Product Change Notification

5201 Power Tamer VS

PCN Number:	EMEPCN-0005
Revision:	1.06
Issue Date:	2019-06-20
Effective Date:	2019-07-01
Author:	Egis Mobile Electric

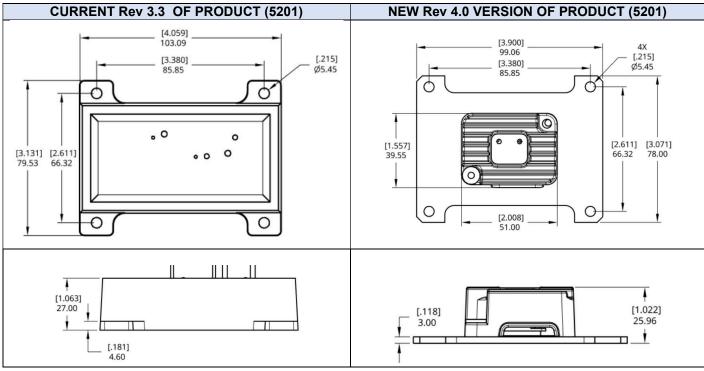
The new revision 4.0 will have a new custom composite housing with new internal printed wiring assembly and on-board components. The overall mounting footprint size for the 5201-2001 and 5601 (sq-in) is 4x to 5x smaller overall. The input and output wire sizes and fuse compartments will be the same, however the new revision 5601B will be shipped with 40 Amp fuses versus the 25 Amp fuses currently supplied on the 5201 due to the higher continuous current capability (30A) of the new product family versus the old product design (20-25A)

The Rev 4.0 Power Tamer VS 5201 is designed to be a drop-in replacement to the legacy Revision 3.3 Power Tamer VS 5201 for customers who require the exact same response and capability. It consists of a 5201-2001 riveted to a larger aluminum mounting plate that is the same footprint as the original 5201.

The new product has wires that exit the product at the mounting surface and directed horizontally. Whereas the legacy product had electrical wires that exit from the top of the device directed vertically.

4 Dimensional & Feature Comparisons

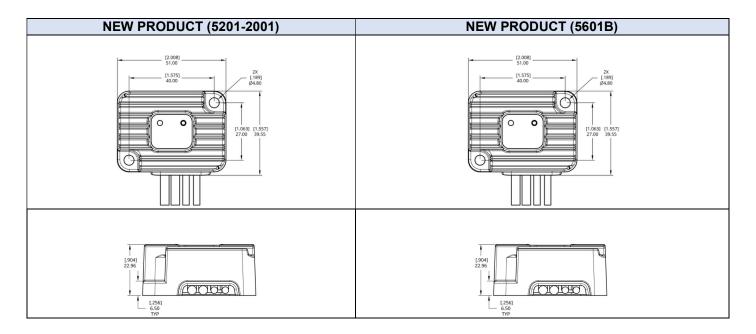
Feature /	5201 Rev 3.3	5201 Rev 4.0	5201-2001	5601B	
Dimension	(Current Version)	(New Revision)			
Power Input Wire	12 AWG Red w/Inline Fuse holder, 12" Long				
Power Output	12 AWG	12 AWG Orange, 24" Long			
Wire	Orange, 18"				
	Long				
Local LED	One Red, One	Single Red / Green Bi-Color			
Indicators	Green				
External Ignition	18 AWG	1	8 AWG Yellow, 24" Lo	ng	
Input Wire	Yellow, 18"				
	Long				
External Ground	18 AWG Black,	18 AWG Black, 24" Long			
Reference Wire	18" Long				
Over Voltage	16.5 V / 15 s	17.0 V / 15 s	17.0 V / 15 s	17.0 V / 15 s	
Protection					
Under Voltage	Always On	Always On	Always On	Optional: Off, 11.0,	
Protection	10.5 Vdc / 15 sec	10.5 Vdc / 15 sec	10.5 Vdc / 15 sec	11.5, 12.0 Vdc	
Voltage Sensing	Always On	Always On	Always On	Dip Switch Option	
Operation				On or Off	
Time Delay	5 sec to 16 hr	5 sec to 16 hr	5 sec to 16 hr	5 sec to 8 hr	
Options					
Location of Dip	Bottom of Unit	Bottom of Unit Under Removable Cover

Switches	Under Label				
Sealing	Water Resistant	Water Resistant	Water Resistant	Water Resistant	
	IP65	IP65	IP65	IP65	
Mounting Hole	Four / #10	Four / #10 Screw	Two / #10 Screw	Two / #10 Screw	
Qty / Size	Screw				
Mounting Space	12.7 sq. inches	12.6 sq. inches	3.2 sq. inches	3.2 sq. inches	
(Device)			(4x smaller)	(4x smaller)	
Volume Space	13.5 cu. inches	13.3 cu. inches	2.8 cu. Inches	2.8 cu. Inches	
(Device)		(5x smaller) (5x smaller)
